Willow Glen Trestle

March 2, 2015

Draft Environmental Impact Report (DEIR)

Fig. 5. Comparison of reduction factors of 0.2% yield strength predicted by AISC, ASCE, and AS 4100 with test results

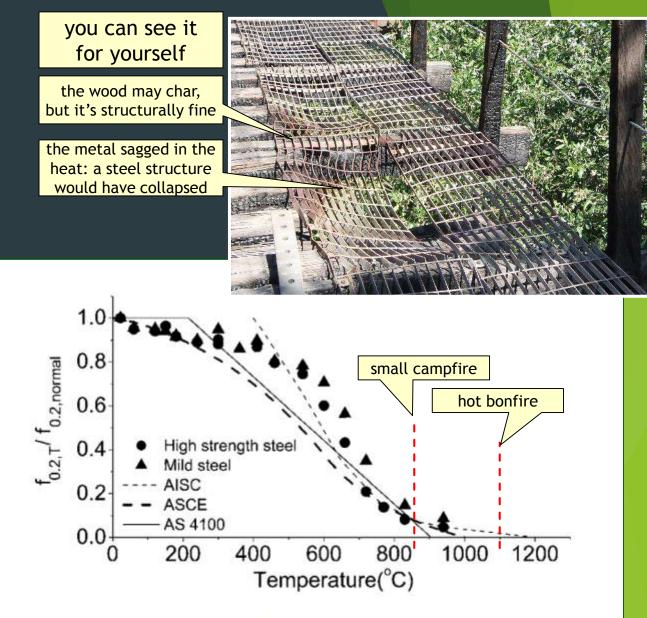
- The trestle is constructed of old-growth redwood - very fire resistant (as evidenced by it still standing after 90+ years)
- Retrofit plans include sprinkler system, alarm system, and fire-retardant treatments
- Fire fighters have ready access over the full length of the trestle, and there are three fire stations within two miles of the trestle
- While steel doesn't burn, it does lose its strength when heated to brush-fire temperatures
- The steel bridge is a truss structure, and, like a chain, it is only as strong as the weakest link: the whole bridge could collapse
- The proposed steel bridge doesn't even include any fire-protection measures no sprinklers, no alarms, and no debris and brush removal

- ► A reasonable precaution
- Should also be done for other bridges across town (but isn't)
- > Should also be done for prefab steel bridge, to reduce probability of metal heat yield

Table 16: Alternative Comparison Matrix

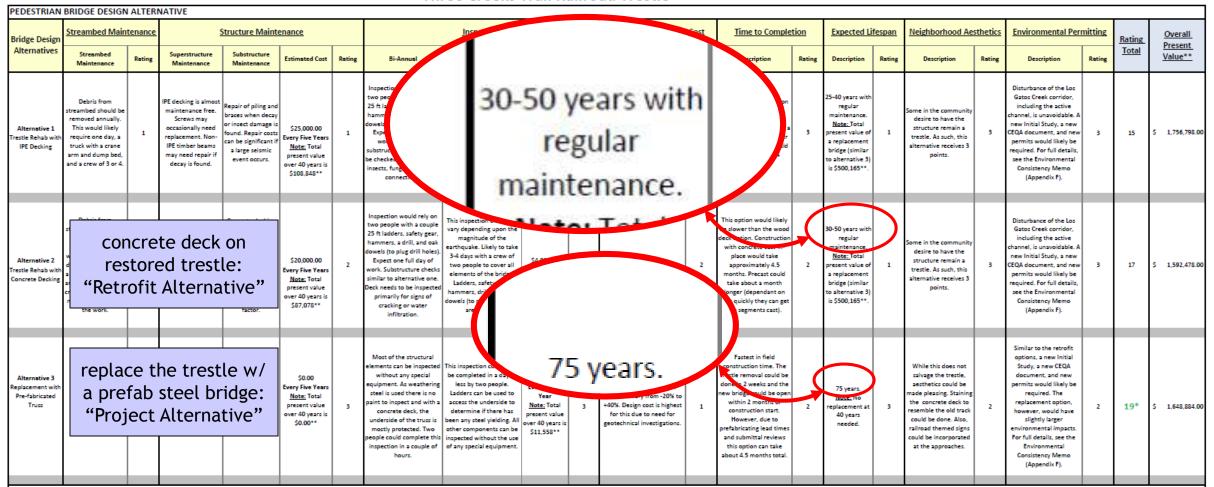
*Recommended Option: Based on analysis of the table above, we recommend Alternative 3 (Replacement with pre-fabricated truss). While there appears to be some community sentiment to keep the existing trestle, it is the most difficult to maintain and inspect. The trestle would require more maintenance of the structure as well as the stream bed than the prefabricated replacement would. In addition, the trestle would have an inspection process that would require more effort and therefore an increased bi-annual cost. The pre-fabricated truss bridge would be the best option for the city based off of overall return on investment (if some sort of streambed maintenence costs were to be included). If it is decided that the trestle should remain then it is our recommendation that the second alternative (trestle rehab with concrete decking) be selected as this option helps to protect the substructure from accelerated water damage.

Table 16: Alternative Comparison Matrix

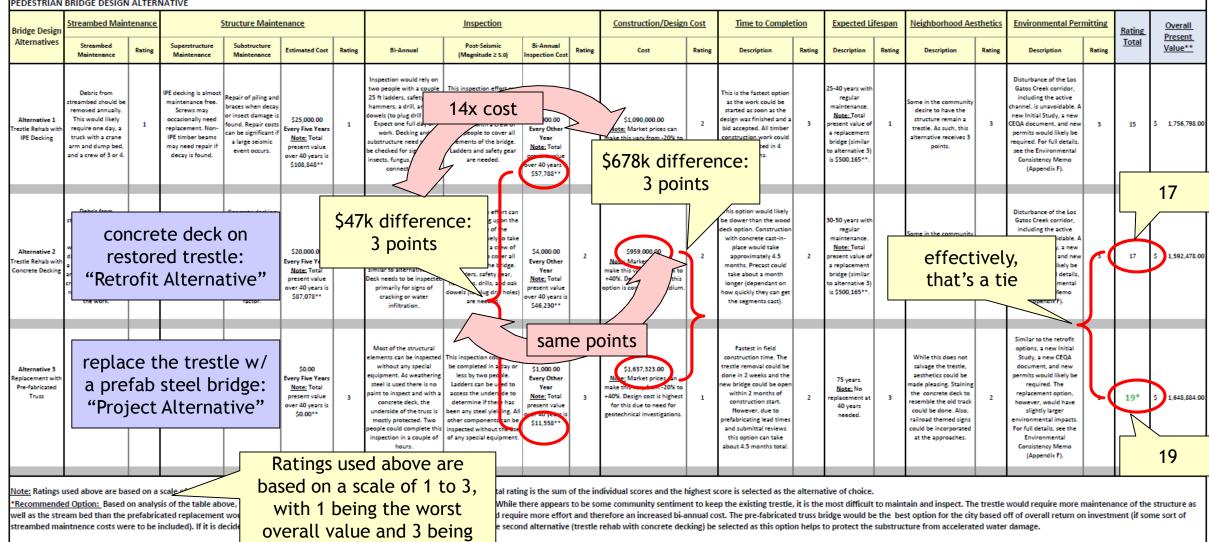
Unweighted Trade Matrix

Table 16: Alternative Comparison Matrix

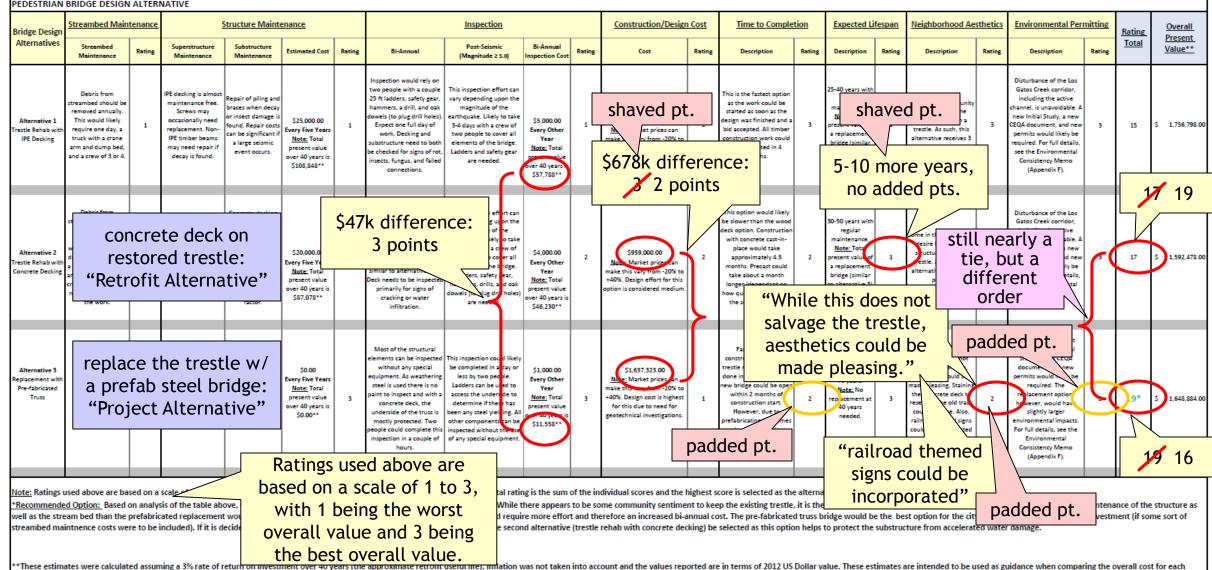
Trade Matrix Significance

- The Executive Summary in the "Initial Study" used the trade matrix as justification for its recommendation:
 - In order to compare all the pros and cons of each option, a comparison matrix was developed and a scoring system applied. It was found that the replacement option had a slightly higher upfront cost, but was the best value for the City over a 40 year time frame. CH2MHILL recommends that the bridge be replaced with a new prefabricated bridge to minimize the long term cost to the City."

the score is the main justification
